REMARKS

Response to the Office Action

AMENDMENT TO THE DRAWING

Fig. 6

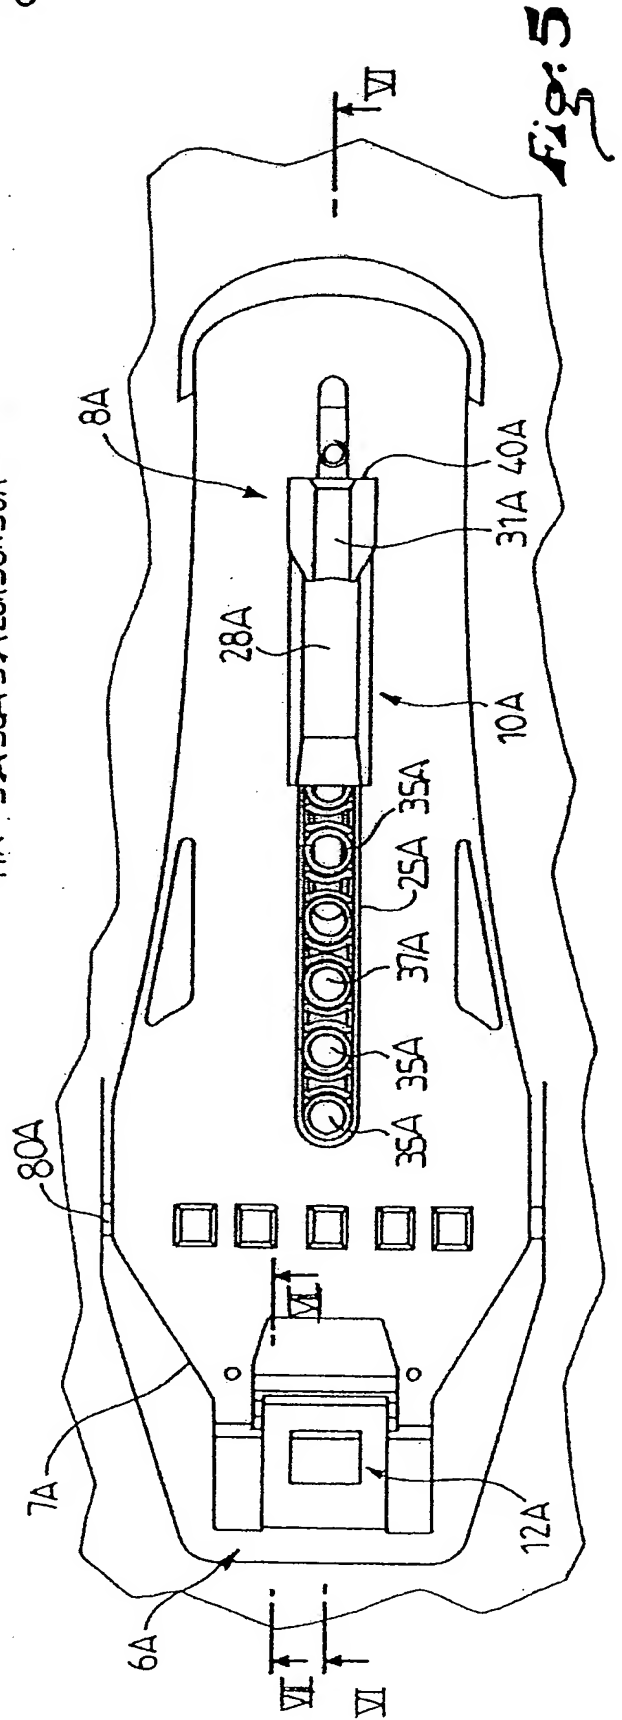
In this section, the Office action objects to paragraph 0032 for referring to boot 11 in Figs. 5-7, whereas Figs. 5-7 fail to illustrate reference number 11.

In Section 10 of the Office action, on page 6, the Examiner remarks that “[i]t is unclear why reference number 15A on Figure 6 does not appear to resemble reference number 15A on Figure 7.

In the Replacement Sheets of drawing, in response to this objection, reference numeral 2 in Fig. 6 has been changed to "11." Accordingly, reconsideration and withdrawal of the objection is kindly requested.

In response, Applicants direct attention to Figs. 6 and 7 being two sectional views taken along two different parallel planes (see Fig. 5), which is believed to account for any significant difference in the appearance of element 15A.

Fig. 3b

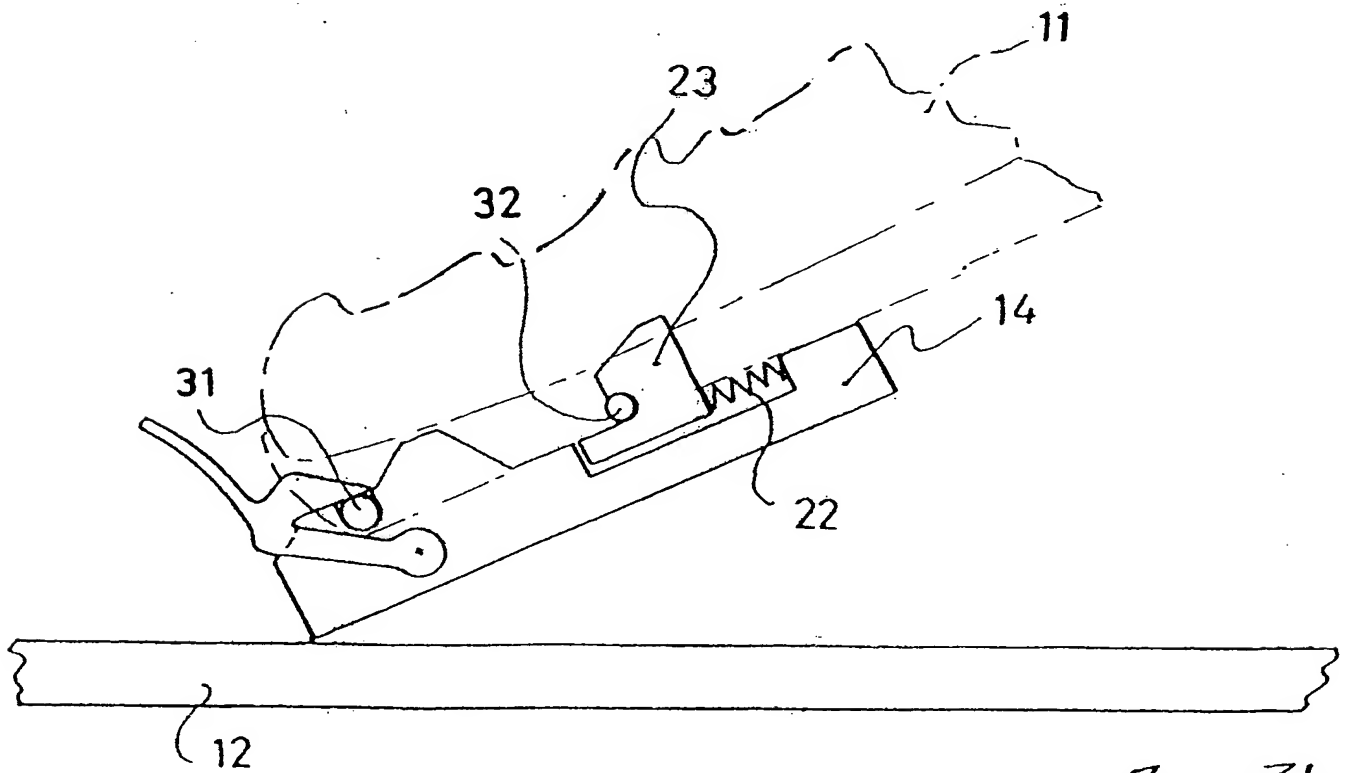
The drawings are further objected to under 37 CFR §1.83(a) for allegedly not illustrating features of the invention that are recited in the claims.

a. Linkage Member Movable Between Low and High Positions, as in Claims 1 and 12

For the purpose of emphasis and clarification, in the Replacement Sheets of drawing attached hereto, Applicants have relabeled original Fig. 3 as Fig. 3a, showing the boot in the "low position" specified in claim 1, and they have added new Fig. 3b, otherwise a duplicate of Fig. 3a, but showing the boot in the "high position" specified in claim 1.

First, regarding the linkage member being movable with respect to the sports apparatus between a low position and a high position, as recited in claims 1 and 12, Applicants have added new Fig. 3b to depict the "high position," consistent with the original disclosure, including paragraph 0018 of the specification. In addition, paragraphs 0015 and 0016 have been suitably amended to refer to Fig. 3b. No prohibited new matter has been added.

New Fig. 3b, therefore, shows in a schematic way, *i.e.*, in a way that is intended to encompass a variety of connections, that the linkage member can be movably mounted relative to the base to a "high" position, Fig. 3a showing the linkage member in the "low" position.

Fig. 8

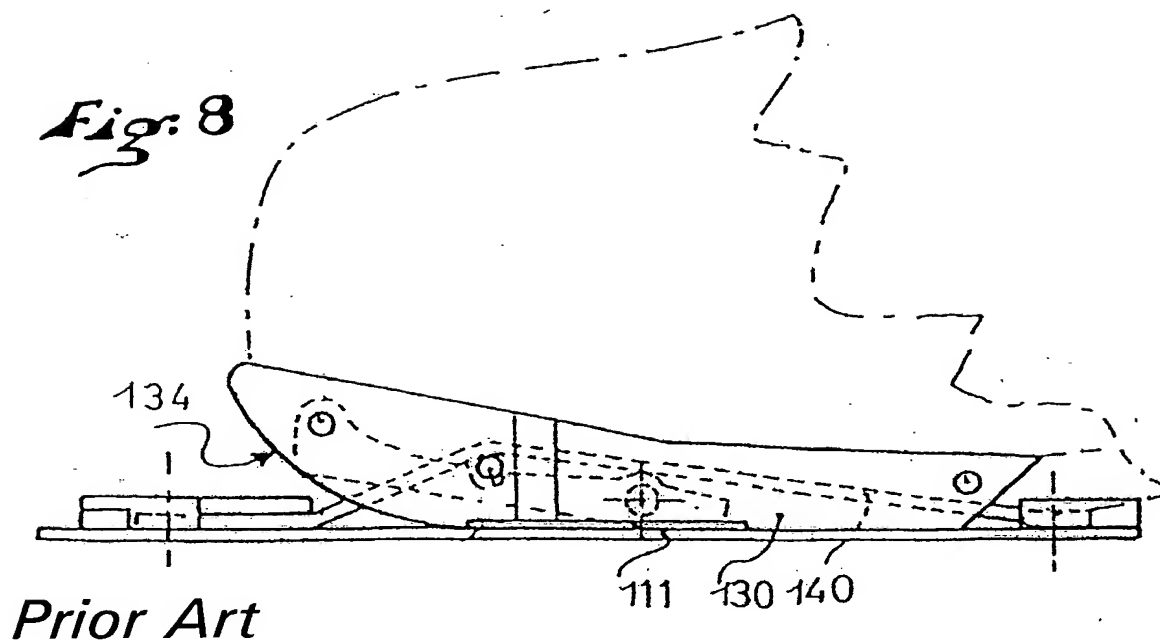
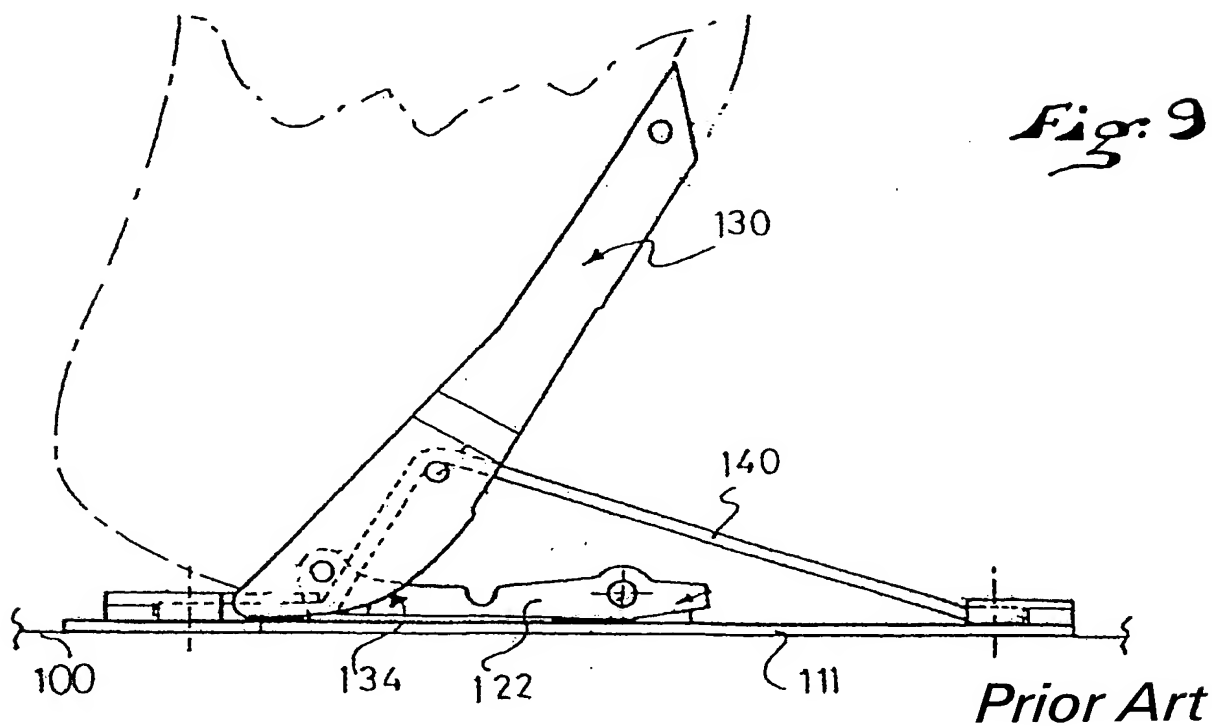
In this section, the Office action includes comments that it is not readily apparent how Figs. 8-11 are "incorporated" into the invention of Figs. 1-4. Further, it is stated that

"the 'linkage member' reference number 14 of Figures 1-4 appears to be fixed to the base of the 'sports article,' whereas the linkage member 130 of Figs. 8, 9, and the linkage member 203 of Figs. 10, 11, appear to be fixed to the boot and not to their respective sports articles 100, 214.

d. Convex Surface, as in Claim 12

In Section 9 of the Office action, on page 5, the Examiner requires that Figs. 8-11 be labeled “Prior Art.”

In response to the objection under 37 CFR §1.83(a) for allegedly not illustrating a “connecting rod,” as specified in claim 11, Applicants direct attention to element 122 of Figs. 8, 9 and elements 216-219 of Figs. 10, 11.

In response to the objection under 37 CFR §1.83(a) for allegedly not illustrating a “convex surface,” as specified in claim 12, Applicants direct attention to element 134 of Figs. 8, 9.

In response, in the Replacement Sheets, each of Figs. 8-11 has been labeled “Prior Art.” Accordingly, withdrawal of the requirement is requested.

Still further, to answer the Examiner's question at the top of page 8 of the Office action, viz., "it is also not apparent what the convex surface set forth in claim 12 is," the convex surface is element 134, for example, described in Applicants' paragraph 0018 and shown in Figs. 8 and 9 (taken from the aforementioned U.S. Patent No. 6,499,761, the disclosure of which is incorporated by reference in Applicants' specification), which
